LTB00814NAS4

# TECHNICAL BULLETIN

501-02: Front End Body Panels

Underhood Lower NVH Pads/Dirty Air Duct Guides Freezing

E191495

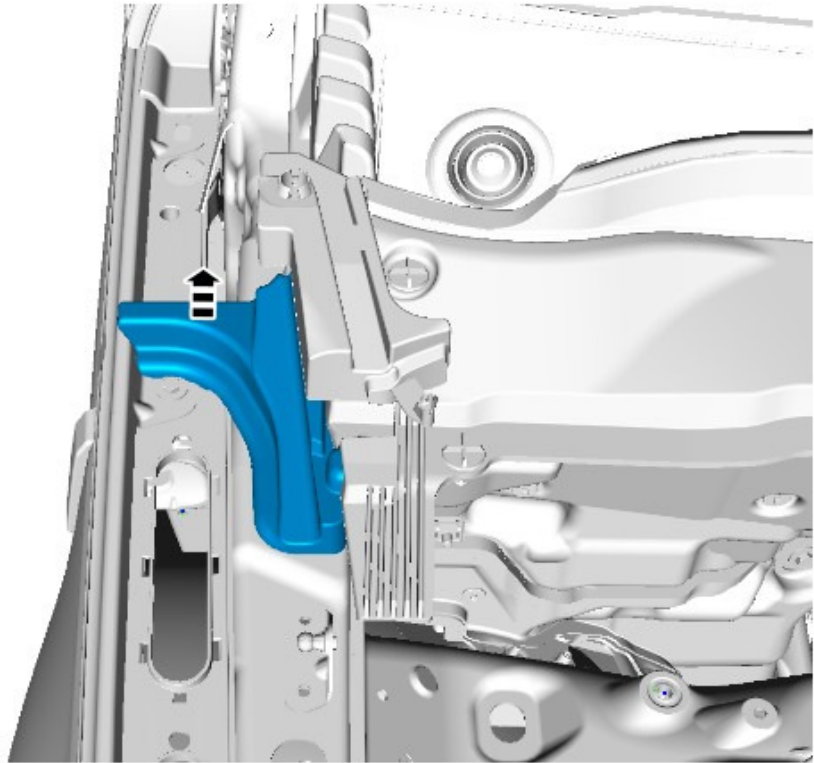
Remove and discard the underhood lower right-hand Noise Vibration Harshness (NVH) pad.

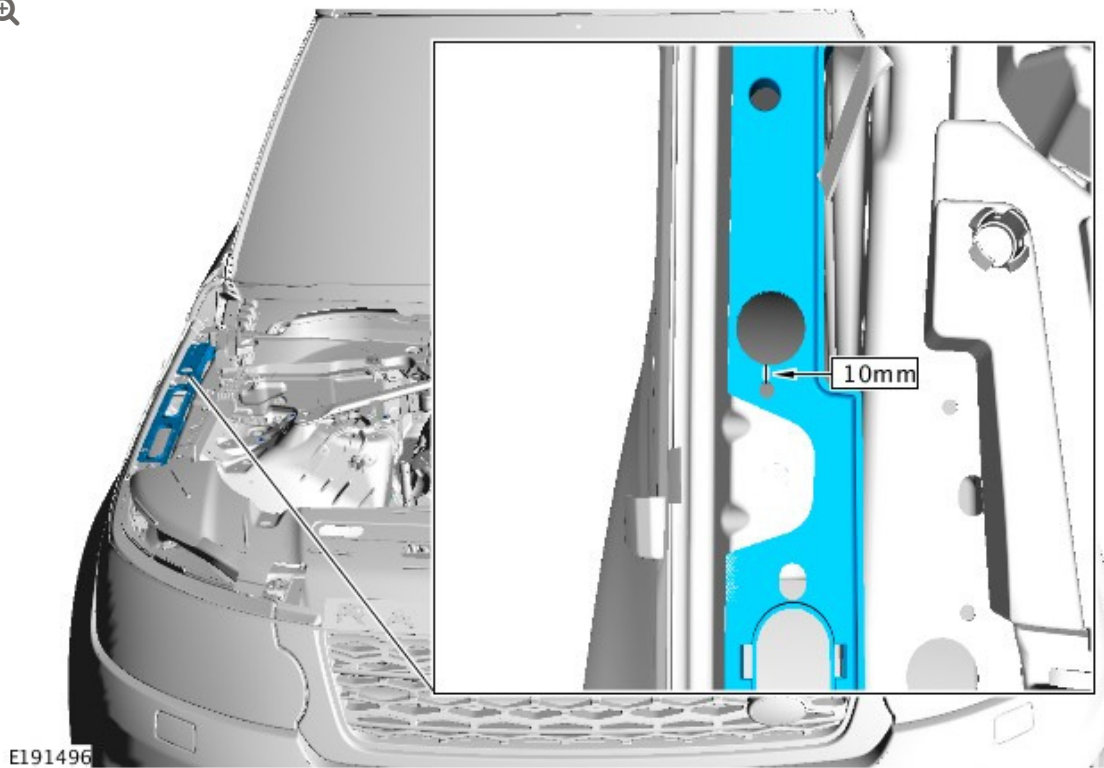
- To avoid cross-contamination (galvanic corrosion), this must be carried out using either a new unused drill bit or an aluminum-repair-only drill bit.
- A Zinc-rich primer must be applied to any bare metal surfaces after drilling.

Drill a new 6.5 mm diameter hole as shown.

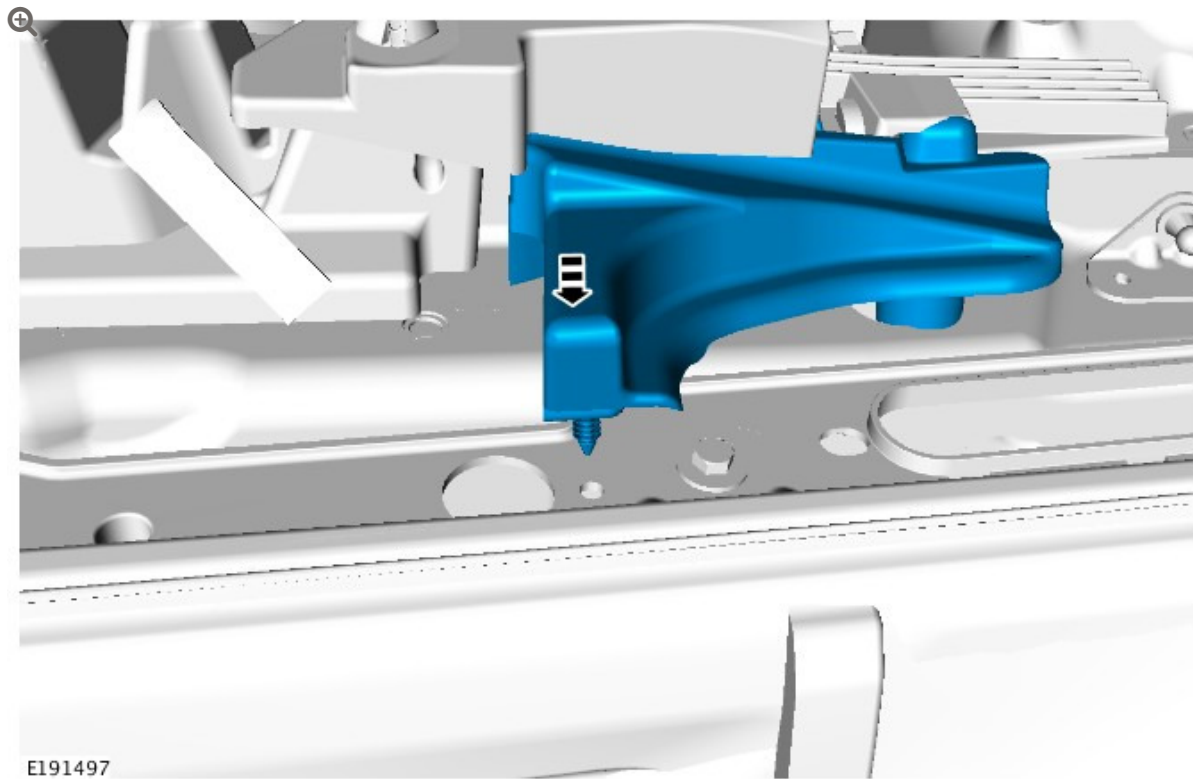
Install the new underhood lower NVH pad.
